**PLAN COMMISSION MEETING
IN PERSON AND VIA ZOOM
TUESDAY, JANUARY 28, 2025 – 4:00 PM
CITY HALL – SECOND FLOOR**

AGENDA

PRELIMINARY PLAT REVIEW REPORT TO THE PLAN COMMISSION

Concept Plan Presentation REPORT TO THE PLAN COMMISSION

PRELIMINARY PLAT

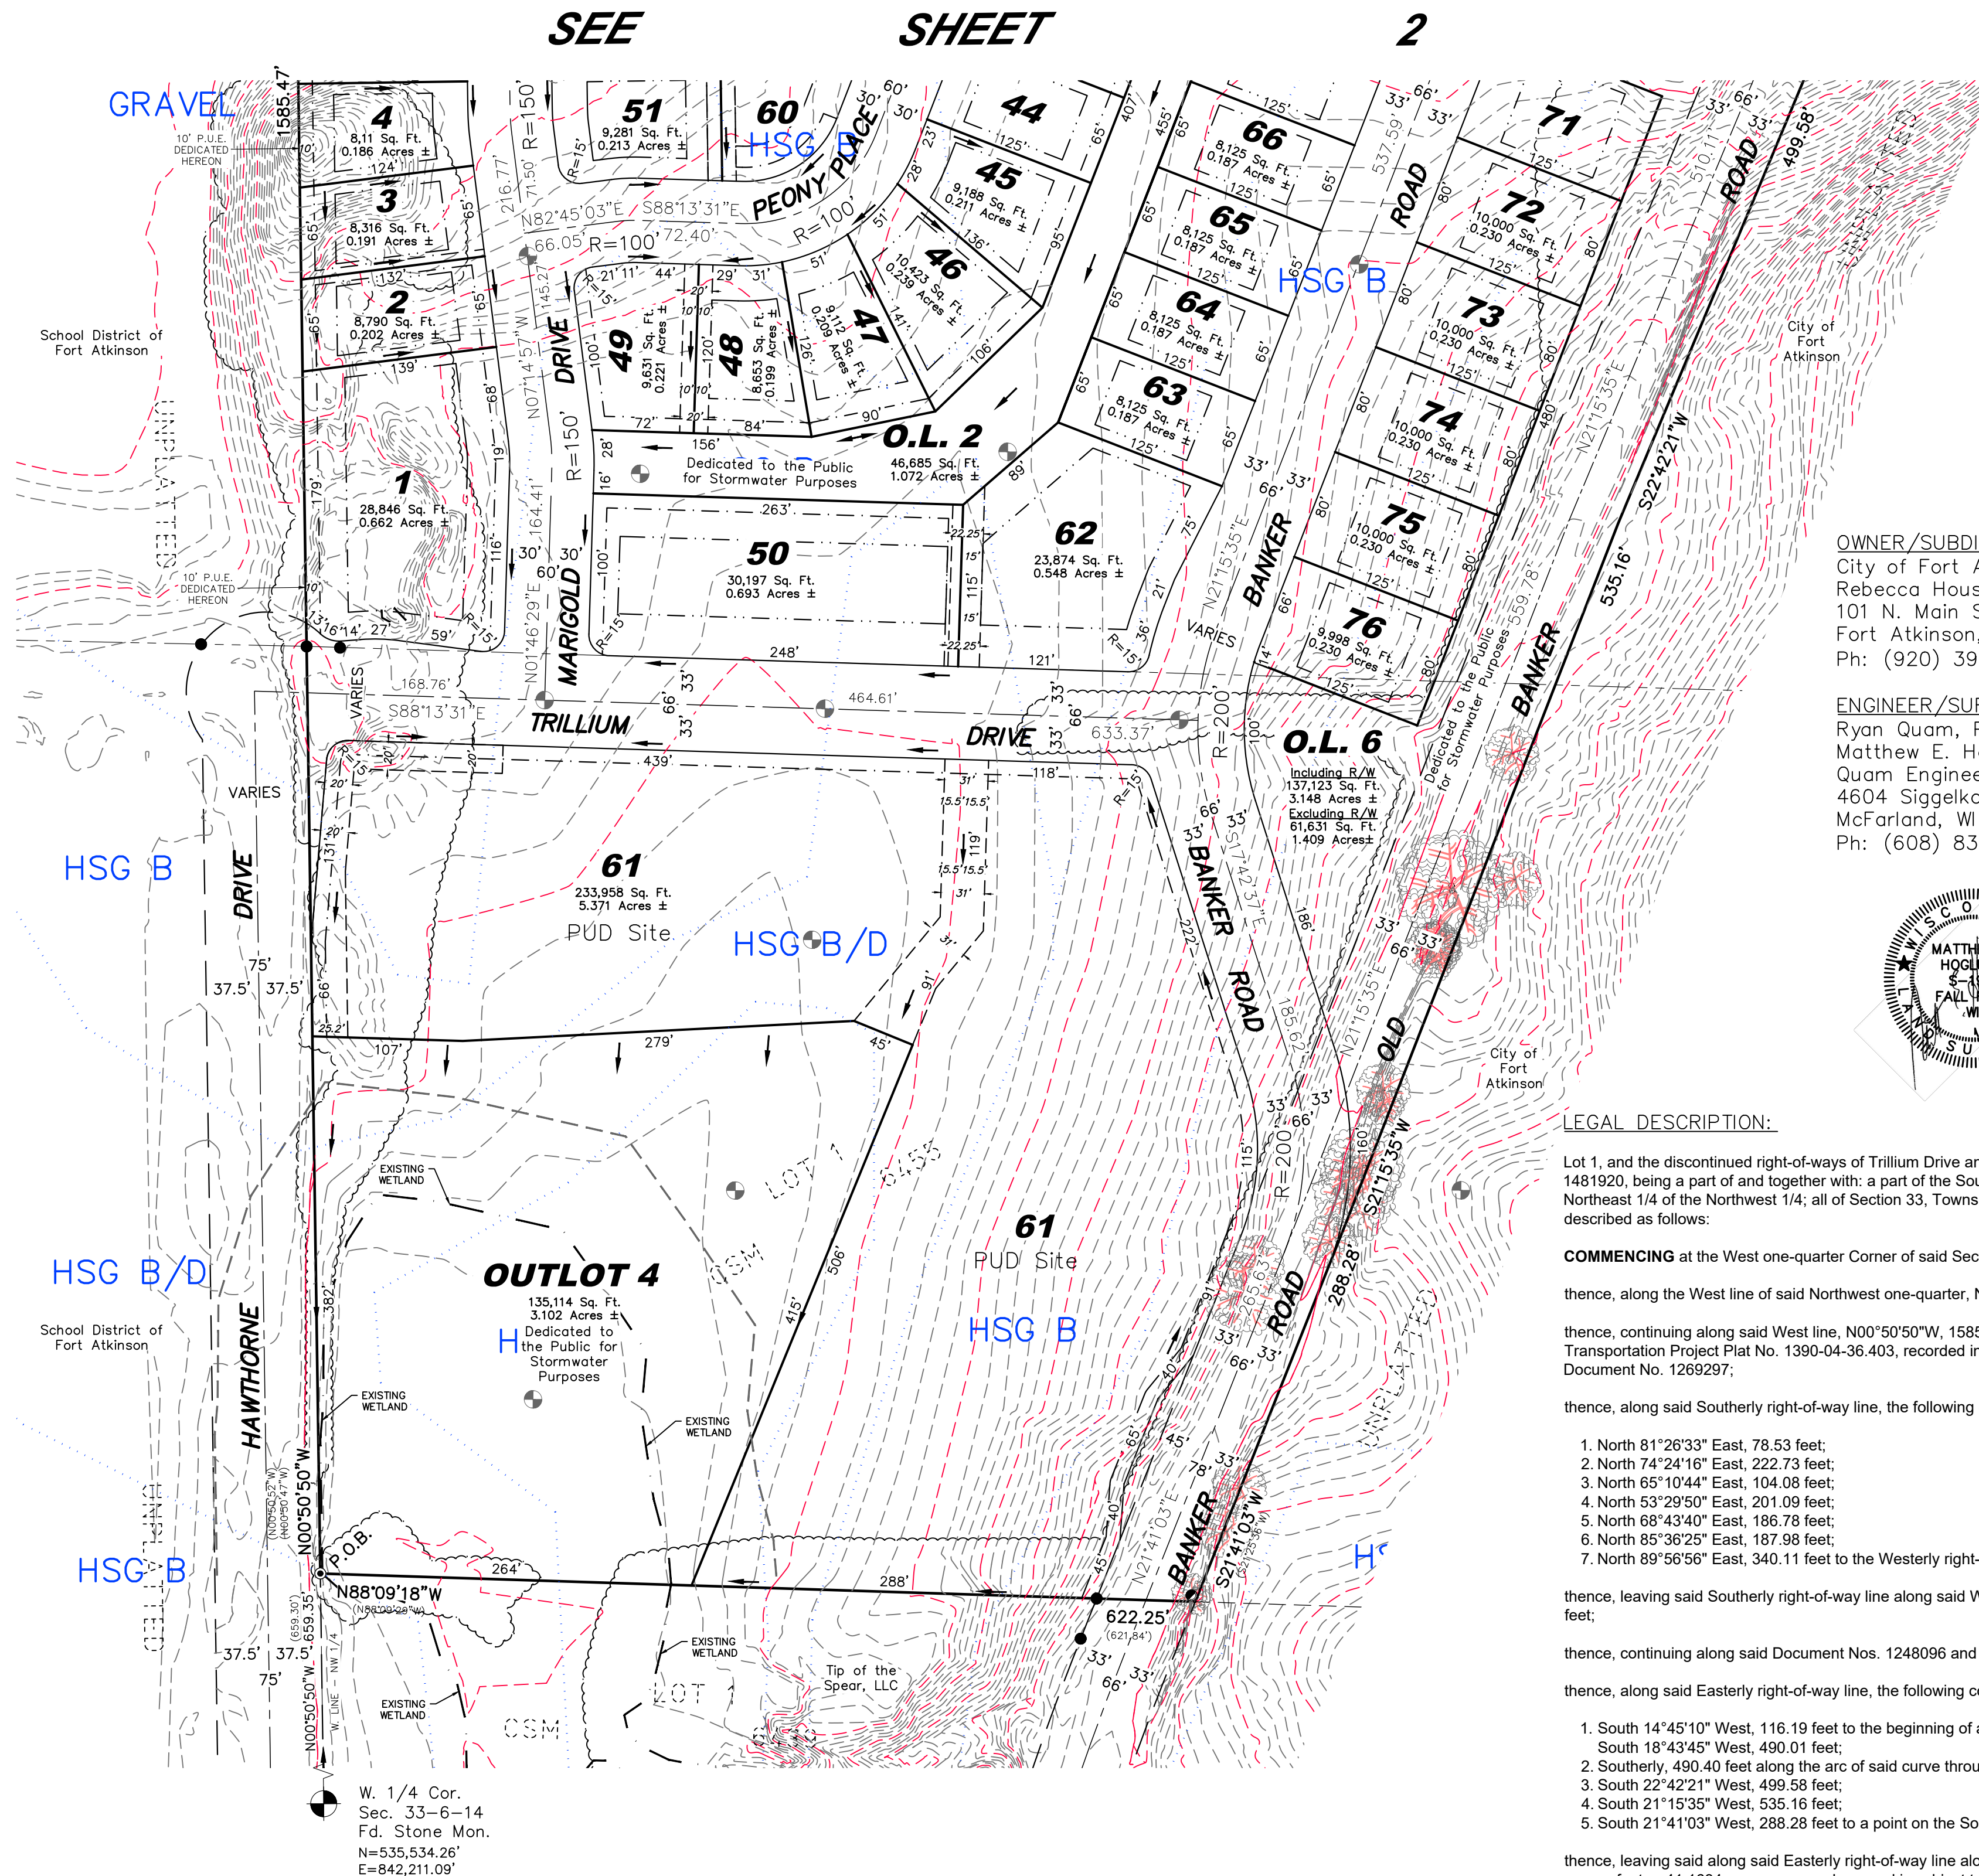
City staff recommends the Plan Commission recommend the City Council approve the Preliminary Map with the conditions listed below:

1. PUD lots to be labeled with each individual lot's base Zoning
2. Outlot 2 to be eliminated and replaced with stormwater easements; bringing all proposed lots into conformity with respect to dimensions
3. Outlot 3 to be eliminated to accommodate changes in road grading per the Design Engineer
4. Utility easements to be shown on Final Plat
5. Set all collector street radius' to city standards
6. Outlots to be described or labeled as CON - Conservancy on Final Plat
